Technical Service Bulletin: TSB110180

Released Date: 11-Jul-2011

New Lubrication Oil Pumps for QSK45, QSK60, QSK60 Gas, and QSK78 Engines

Figure 1

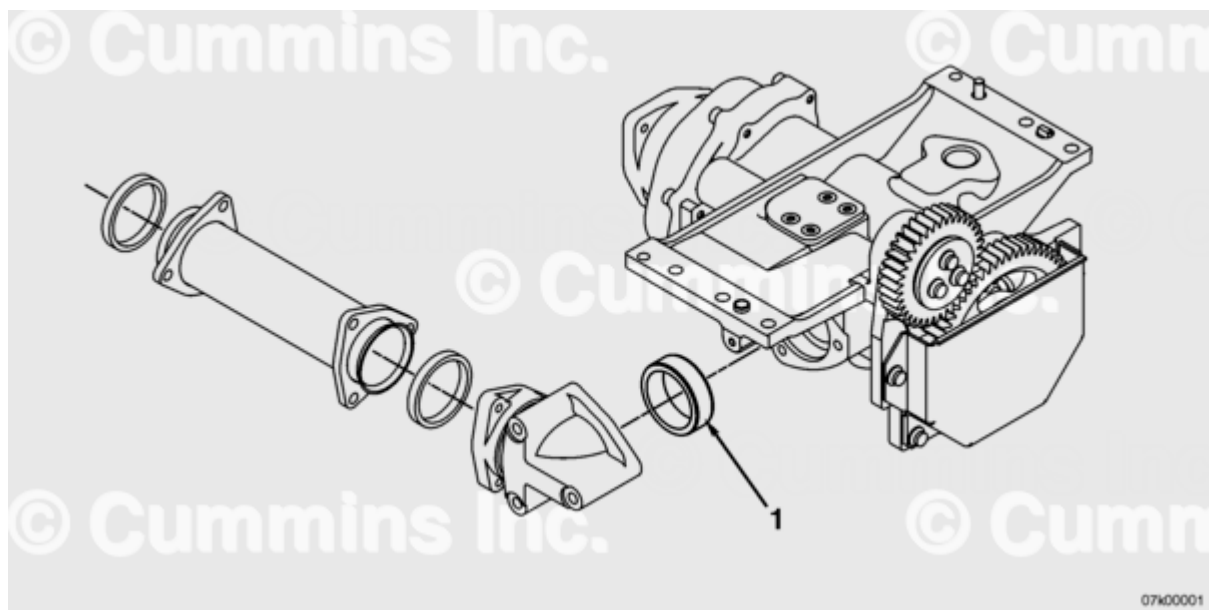
An additional change being introduced is the deletion of the pump outlet port sleeve (See Fig 1, item 1, Part Number 4916879). This sleeve was previously installed to match the lubrication oil pump outlet port diameter to the oil supply tube diameter. The outlet port in the pump body has been modified to be the same diameter as the oil supply tube, making the sleeve obsolete. The sleeve will remain available for service on the old part number pumps.

1. Lubrication Oil Pump Outlet Port Sleeve.
